PRODUCT INFORMATION BULLETIN

Date: September 22, 2015
Number: 8889
Division: Genie®
Product Family: Commercial Operators
Product Series: Genie Commercial GCL-T and GCL-GT Trolley Systems
To: All Genie Professional Line Wholesalers, Dealers and Installers
Re: Heavy and Standard Duty Dual Trolley Improvements

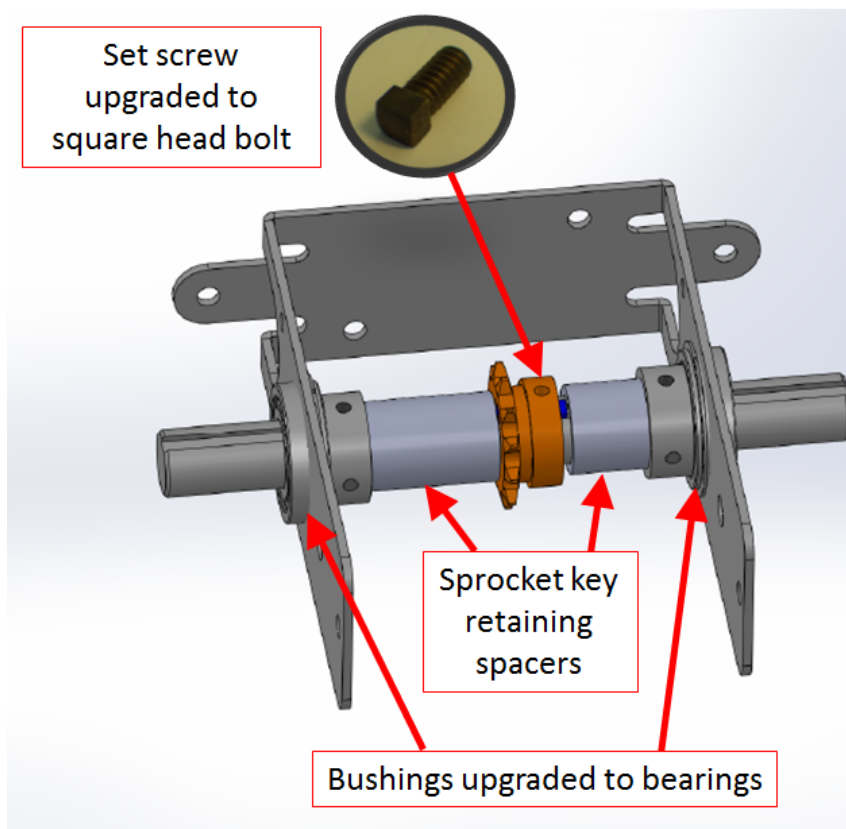
Several changes have been made to the standard-duty (OPAKDT.S) and heavy-duty (OPAKDTHX.S) dual trolley kits.

Bushings on the header bracket assembly have been upgraded to bearings to improve reliability. In addition to the change, spacers have been added on both sides of the header sprocket to retain the key position in the event that the sprocket bolt loosens. The set screw in the sprocket has also been changed to a square head bolt to improve the ability to apply torque when tightening the sprocket to the header shaft. All these changes were in effect as of September 17, 2015.
